# Review of the Readout schema

# Observations on first version of OKS schema

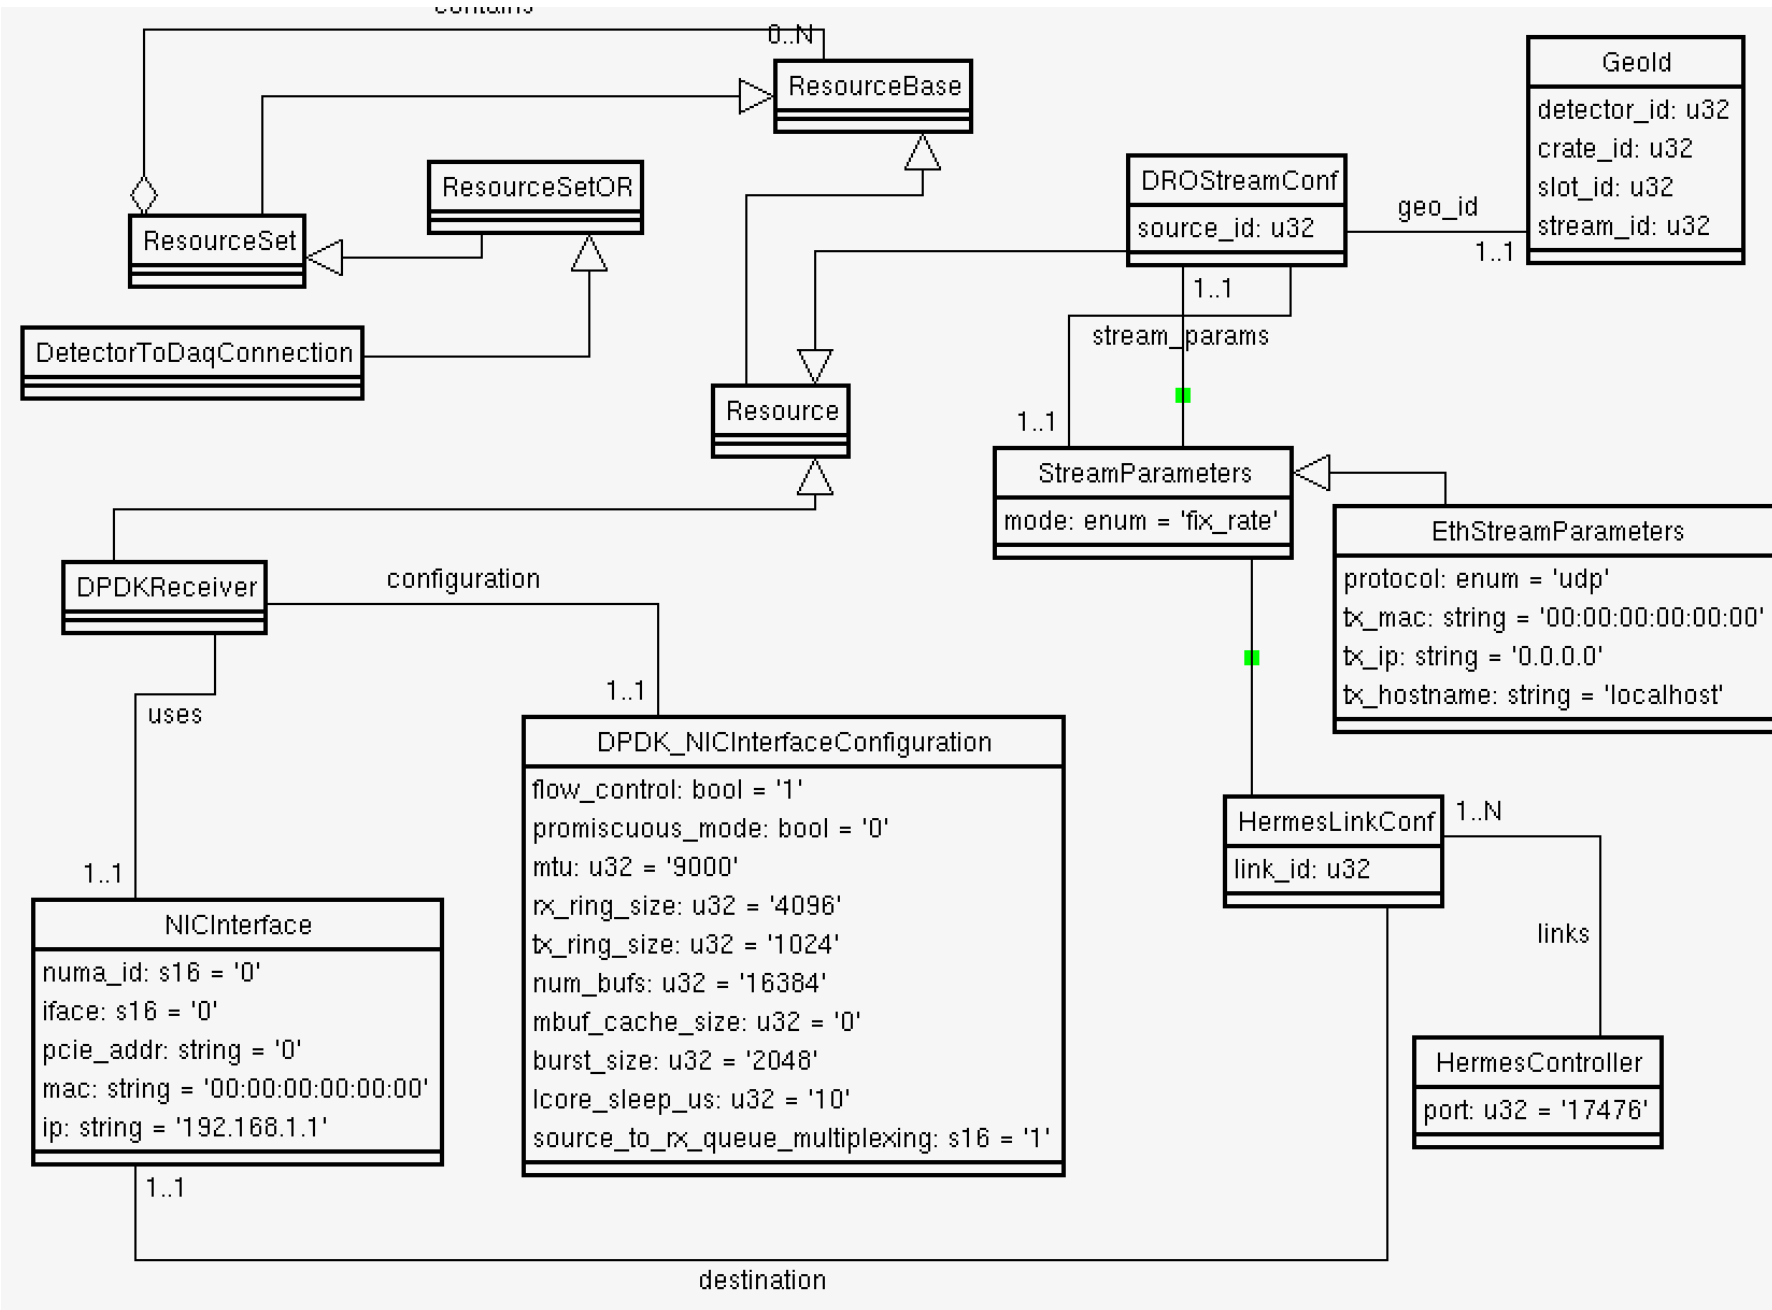
- Unclean separation of detector streams and receiving endpoint (streams contained in the NICInterface class, streams containing lcore/rx\_queue information which are receiver properties....)
- Mix of hardware properties and configuration settings (MAC address, dpdk parameters, ...)

We decided to revise the schema “at the whiteboard” to improve modularity and maintainability.

- Introduced a `DetectorToDaqConnection` class which contains
  - A group of detector streams (only sender properties)
  - One `DPDKReceiver`
- If one wants to change the receiver for one detector unit (e.g. one APA) it is sufficient to change the `DPDKReceiver` object used in the connection. 😊
- What is a `DPDKReceiver`?
  - It's a class linking a `Hardware NICInterface` with a set of chosen DPDK specific configuration settings (class `DPDK_NICInterfaceConfiguration`)
- Why is this a good approach?
  - For the same `NICInterface` hardware we may want to test different DPDK configurations without affecting the hardware properties that are described "once for good".
  - Several `DPDKReceivers` may use the same DPDK configuration, running on different `NICInterfaces`

# Update since last week

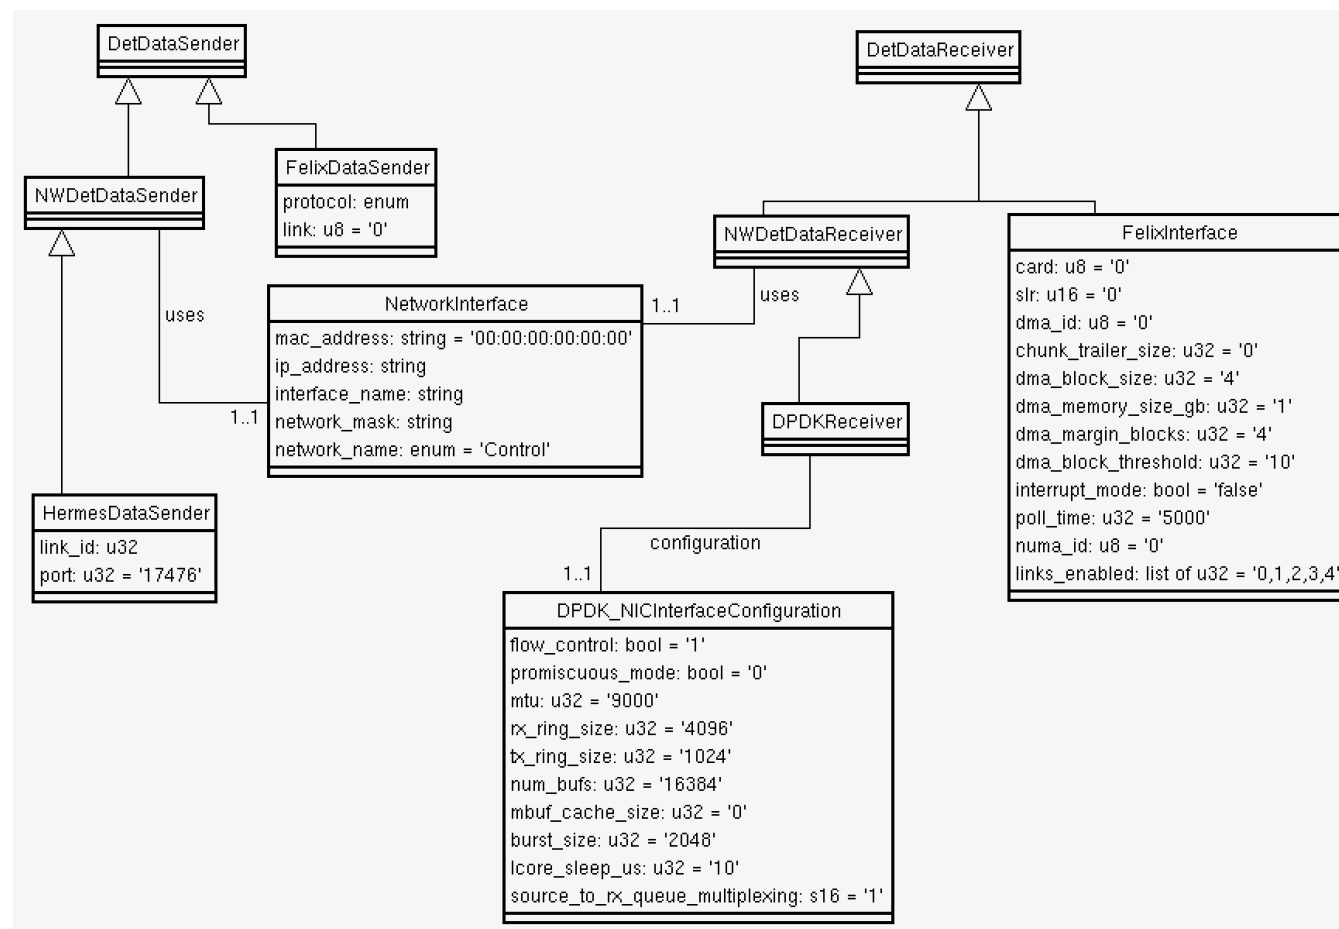
- Abstracted and generalised the concept of DetDataSender and DetDataReceiver
- A DetToDaqConnection typically contains one DetDataReceiver and a set of DetDataSenders
- Adapted for FELIX and should be on track for ND

# Hermes Schema

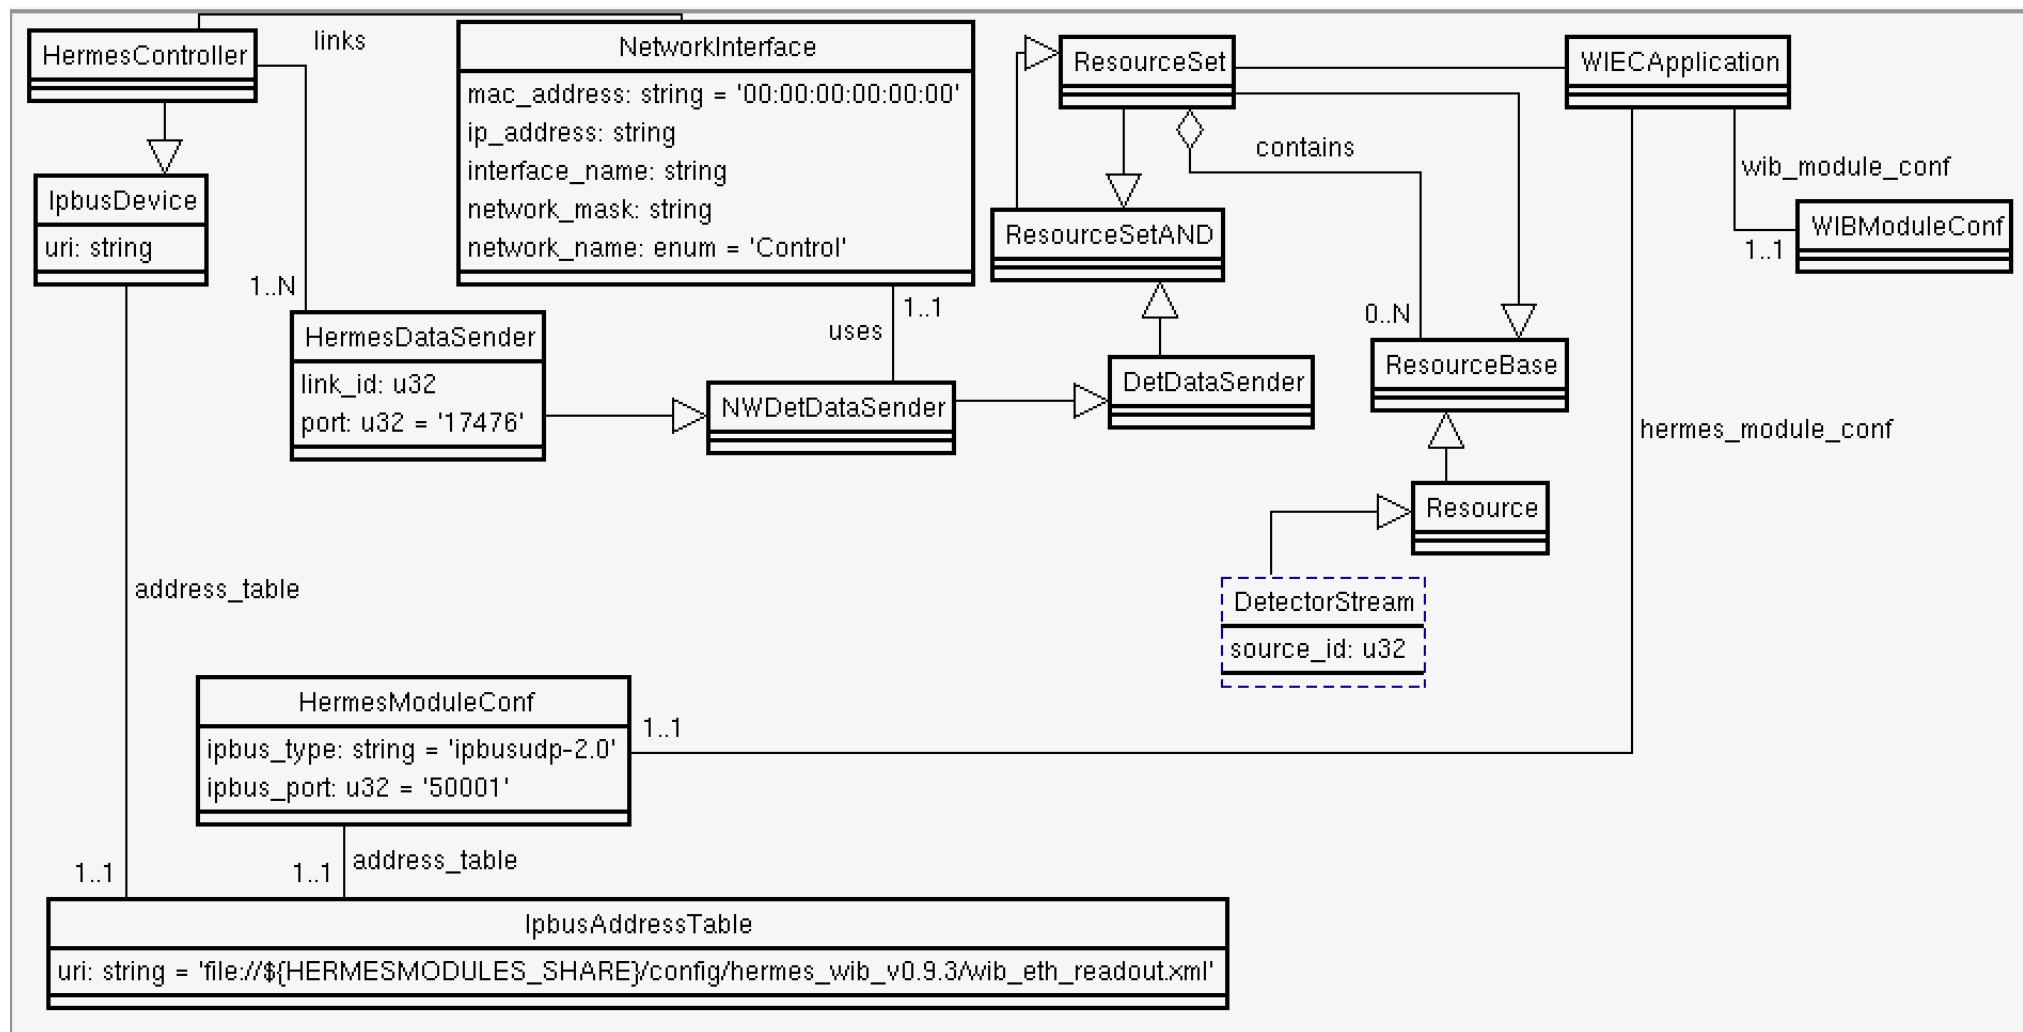
- Instead of pointing to the old NICInterface(s) the ReadoutApplication now points to one or more DetectorToDaqConnection(s)
- The generate\_modules() method for the ReadoutApplication needs to be updated accordingly
- Other algorithms (for other smart apps) need minor adjustments.
- The Hermes schema was updated to used the smart application concept and have a clean split of hardware/configuration properties
